Product / Process Change Notification

N° 2005-161-A

Change of naming: CoolMOS CS to CoolMOS CP, datasheet specification changes within the respective datasheets

IPW60R045CS (2-2)

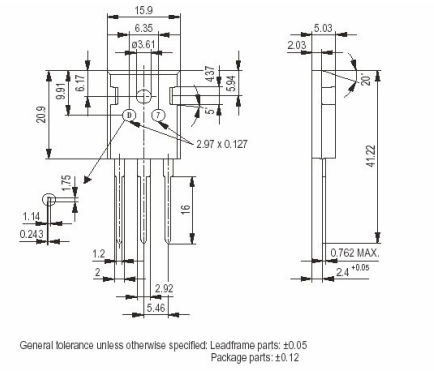
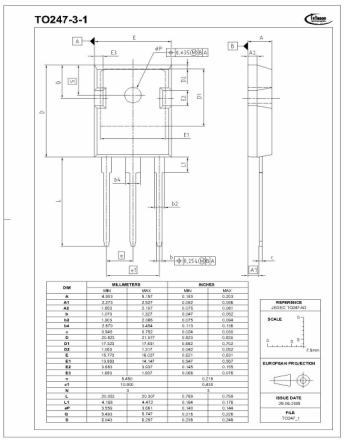
Actualization of package drawing
(p. 9 datasheet)

for details see datasheet attached

IPW60R099CS (2-2)

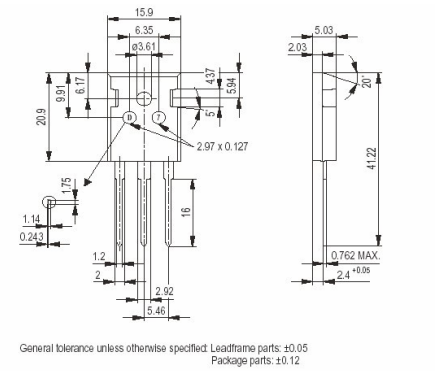
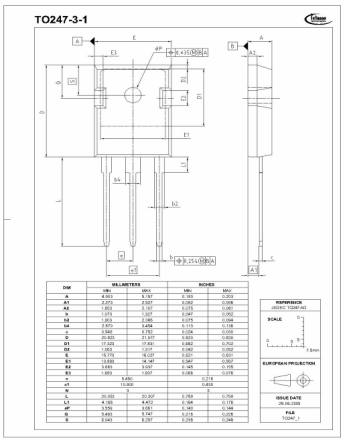
Actualization of package drawing
(p. 9 datasheet)

for details see datasheet attached

IPP60R099CS (2-2)

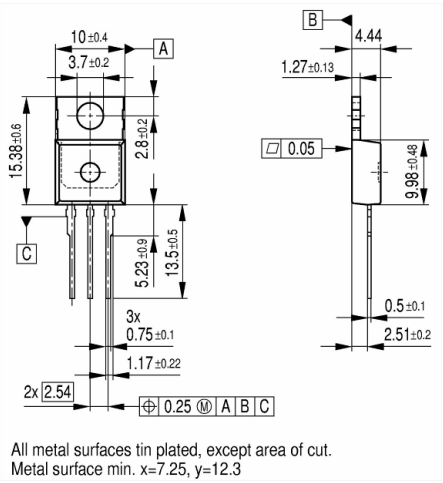
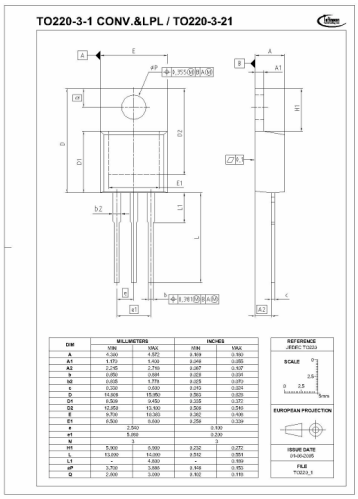
Actualization of package drawing
(p. 9 datasheet)

for details see datasheet attached
